JB TERMINATION DRAWING

PROJECT NAME: BINAK OILFIELD DEVELOPMENT SURFACE WORK PACKAGES

SCALE	SIZE	DRAWING NO.	SHEET NO.	REV.
N.T.S.C.	A3	BK-GCS-HY-120-IN-DW-0003	15 OF 16	V02

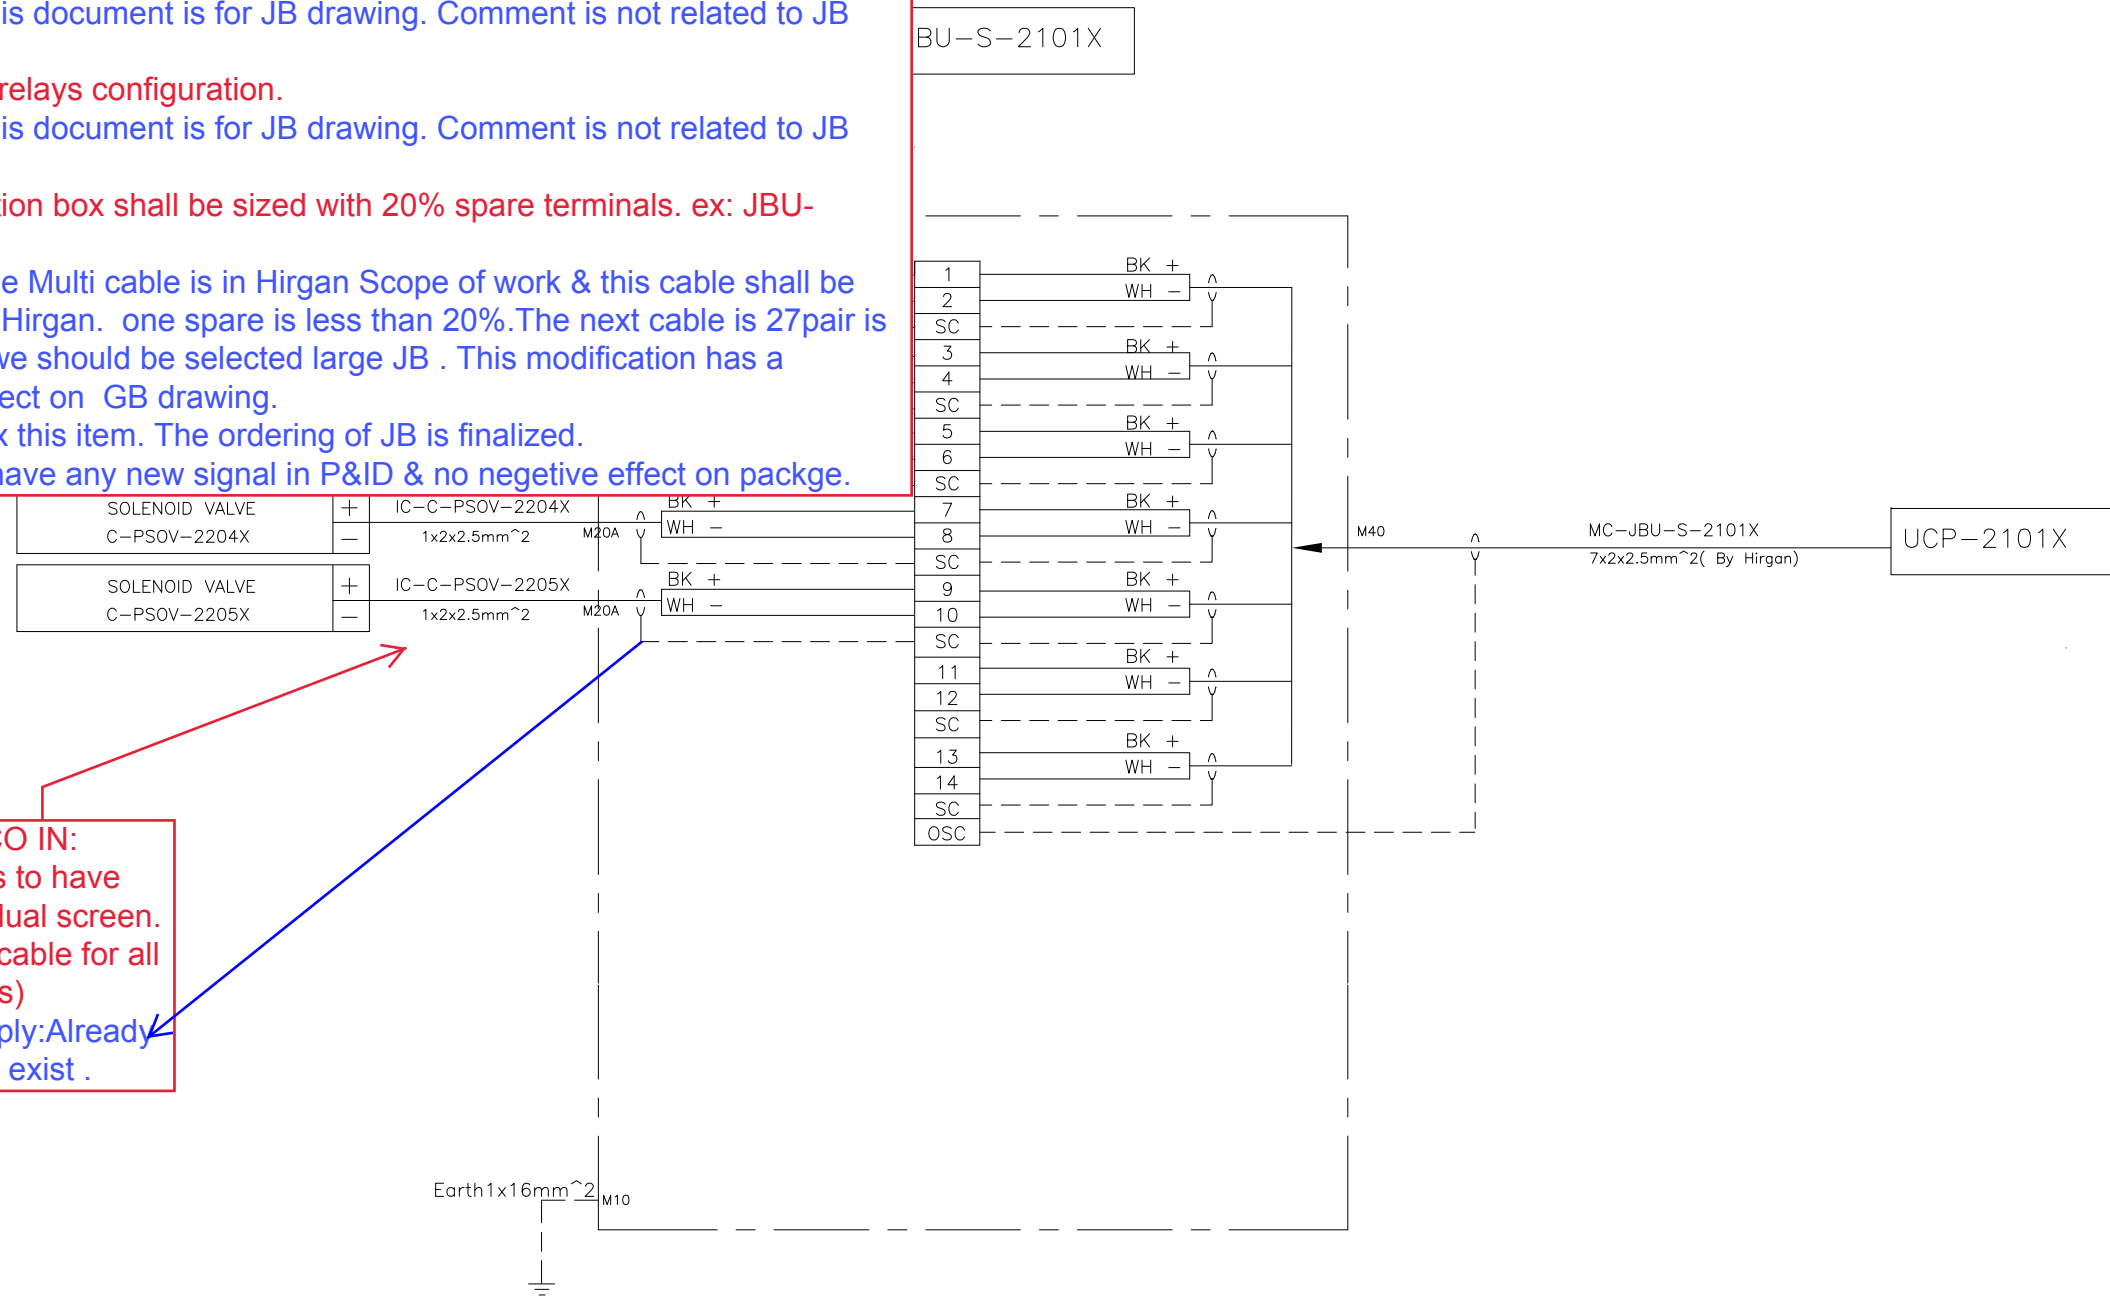
- Alarms in UCP to be shown
- Connection between LCP and UCP shall be clarified.

- Connection between UCP and DCS shall be clarified.

- Connection between MCC and LCP/UCP and vice versa shall be clarified.

- Clarify for relays configuration.

- Each junction box shall be sized with 20% spare terminals. ex: JBU-A-2101

HY reply: This document is for JB drawing. Refer to LCP document.

HY reply: This document is for JB drawing. Comment is not related to JB drawing.

HY reply: This document is for JB drawing. Comment is not related to JB drawing.

HY reply: This document is for JB drawing. Comment is not related to JB drawing.

HY reply: The Multi cable is in Hirgan Scope of work & this cable shall be finalized by Hirgan. one spare is less than 20%. The next cable is 27 pair is too over & we should be selected large JB. This modification has a negative effect on GB drawing.

Please relax this item. The ordering of JB is finalized.

We do not have any new signal in P&ID & no negative effect on package.

TAG NO.: JBU-S-2101X

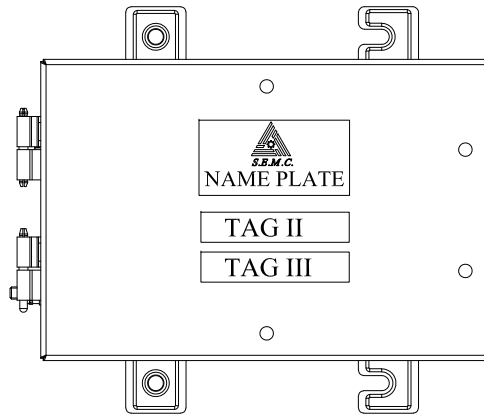
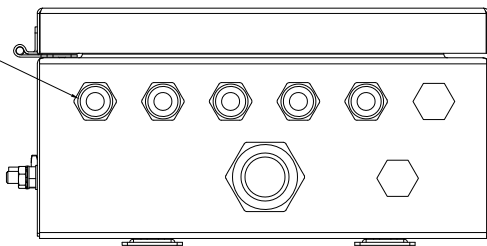
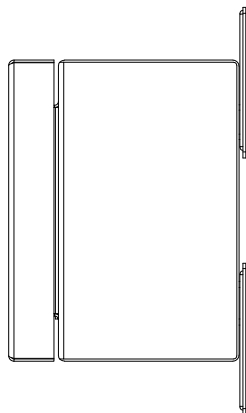
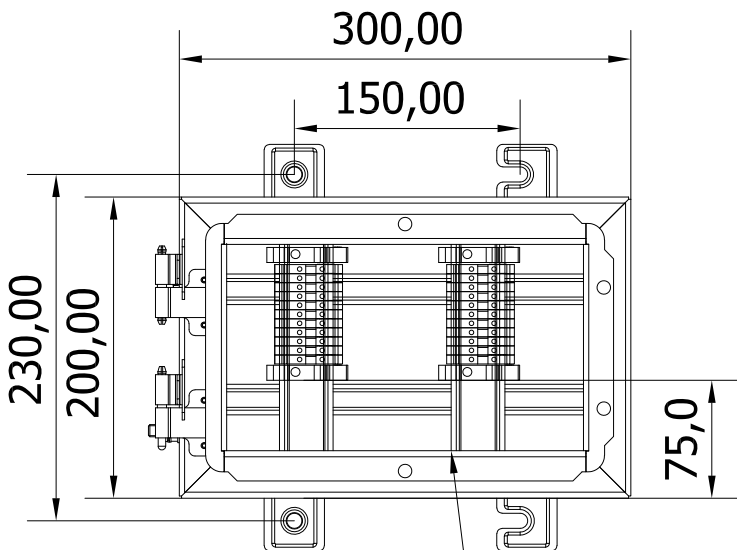
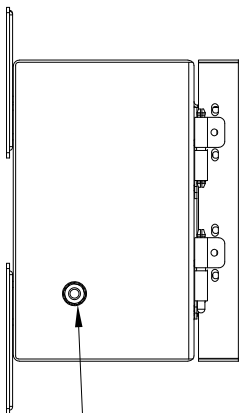
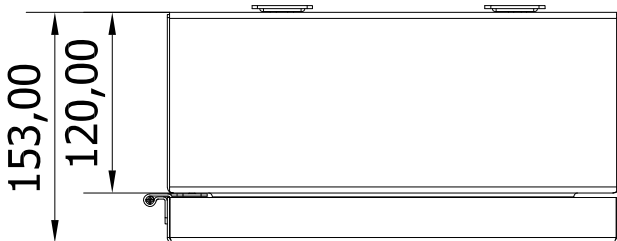
PEDCO IN:
cables to have
individual screen.
(Applicable for all
Cables)
HY reply:Already
ISC is exist .

TAG NO.: JBU-A-2101
HIRGAN JB

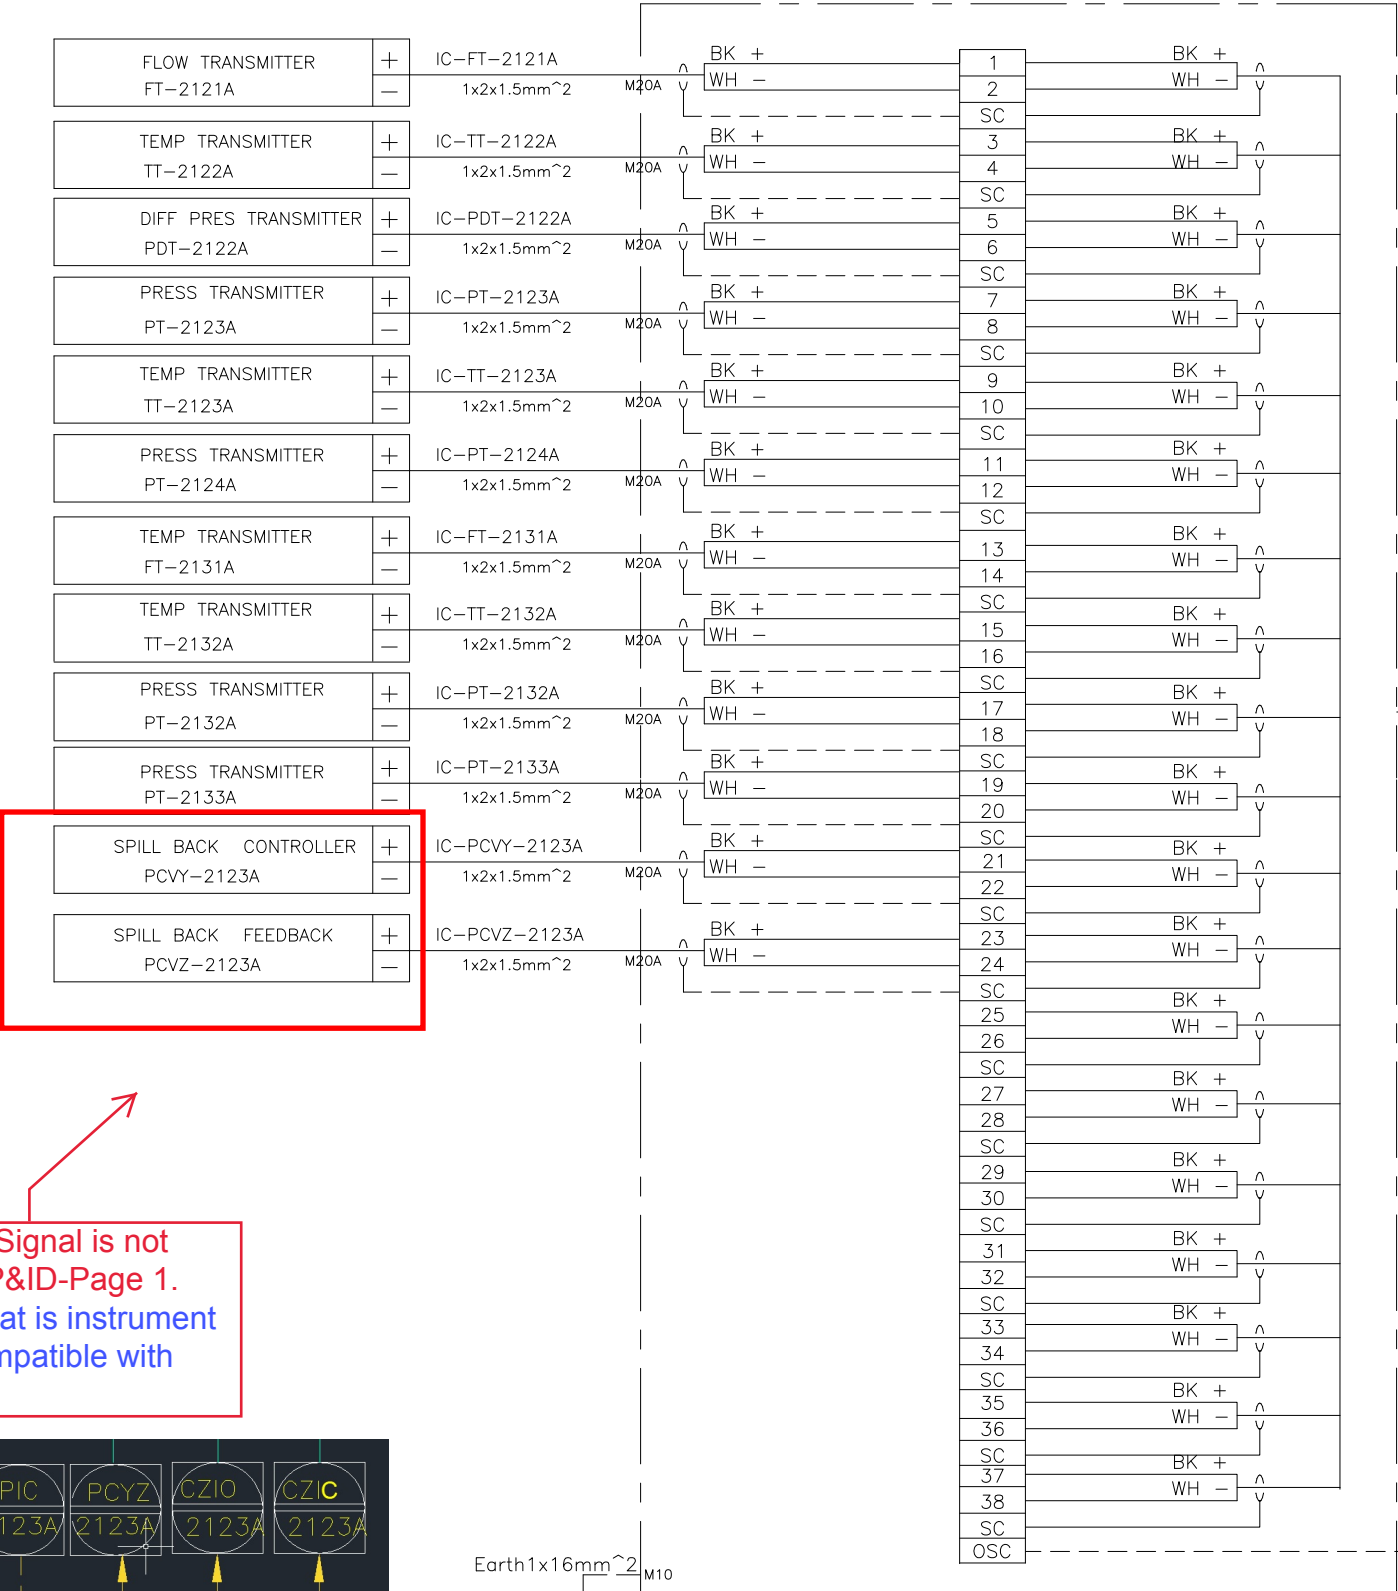
TT-2133 is missed.
HY reply:
TT-2133 & PDT-2132
Added.

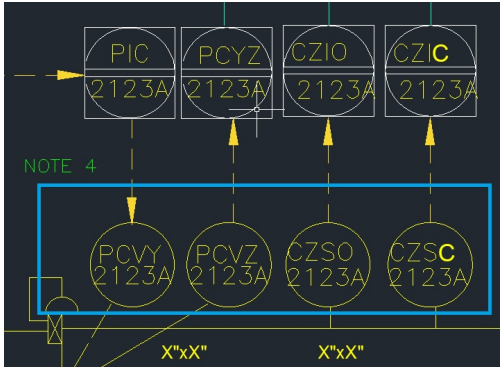
PEDCO IN: Signal is not
match with P&ID-Page 1.
HY reply: That is instrument
tags & is compatible with
P&ID.
